Access Compliance Report

Public Rights-of-Way

Intersection ID: 21831	Main Street: ENGLAND_ST	Cross Street: WINDSOR_OAK_CT	Location: SW
ADA ID: 6C771A3F72F0	Ramp Type: PerpDiag	Initial Pass/Fail: Fail	Overall Compliance: No
Severity Score: 13.75			
Codes/Mitigation Info/Possible Solution		Field Measurements/Component Compliance

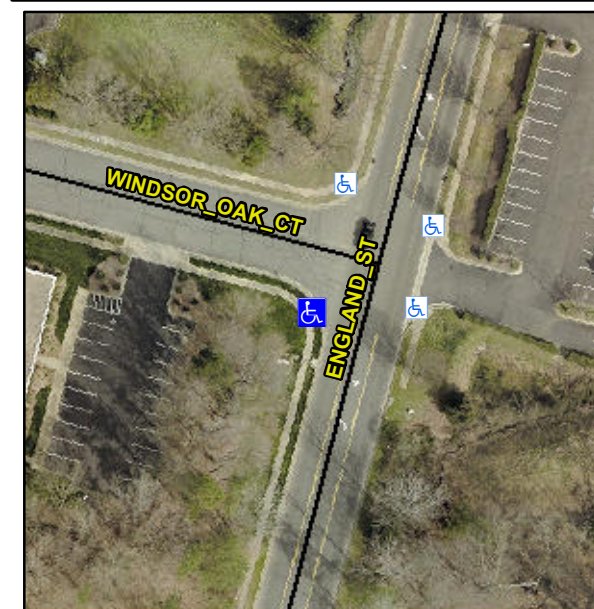
Not Found, R304.2.2, R304.5.3

Compliance	Description	Data	Compliance	Description	Data
N/A	Ramp Length (in)	93.0	No	Ramp Slope (%)	8.7
Yes	Ramp Width (in)	48.0	No	Ramp XSlope (%)	4.1
N/A	Flare Type LT	N/A	N/A	Flare Type RT	N/A
N/A	Flare Slope LT (%)	N/A	N/A	Flare Slope RT (%)	N/A
N/A	Flare Traversable LT?	N/A	N/A	Flare Traversable RT?	N/A
N/A	Landing Length (in)	N/A	N/A	DWS Provided?	N/A
N/A	Landing Width (in)	N/A	N/A	DWS Contrast?	N/A
N/A	Landing Slope (%)	N/A	N/A	DWS Length (in)	N/A
N/A	Landing X Slope (%)	N/A	N/A	DWS Full Width?	N/A
N/A	Landing Curb? (Y/N)	N/A	N/A	DWS Offset (in)	N/A
N/A	Shared Landing?	N/A			
N/A	Gutter Ponding?	N/A	N/A	Gutter Slope (%)	N/A
N/A	Gutter Lip Ht (in)	N/A	N/A	Gutter X Slope (%)	N/A
N/A	Painted X Walk1?	No	N/A	Painted X Walk2?	No
	X Walk 1 Direction	To SE		X Walk 2 Direction	To NE
N/A	X Walk 1 Width (in)	N/A	N/A	X Walk 2 Width (in)	N/A
	X Walk 1 Slope (%)	2.1		X Walk 2 Slope (%)	3.4
	X Walk 1 X Slope (%)	4.3		X Walk 2 X Slope (%)	1.2

Remove & Replace Curb Ramp With Two New Directional Ramps or Equivalent.
